## **PLAN REVIEW SHEET**

Petition: 2013-094 Telephone:

Halvorsen Development Corporation

**Bus Shelter and Pad Spec**

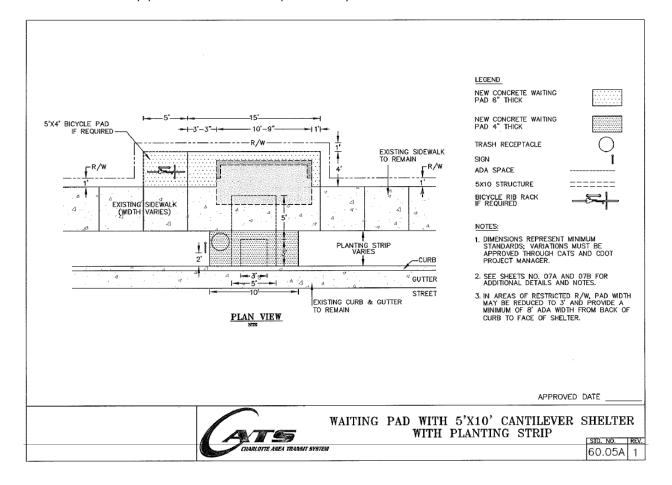
The Petitioner is requested to construct a shelter pad on Ridge Road for new express bus service to Uptown Charlotte. The location of the stop is flexible and may work on any one of the multiple curb extensions along Ridge Road.

The CATS standard for a shelter and waiting pad is also shown below. If provided the concrete pad, CATS will be responsible for installing a standard shelter. If seeking a unique shelter design, the developer needs to provide the shelter structure and coordinate its design with CATS.
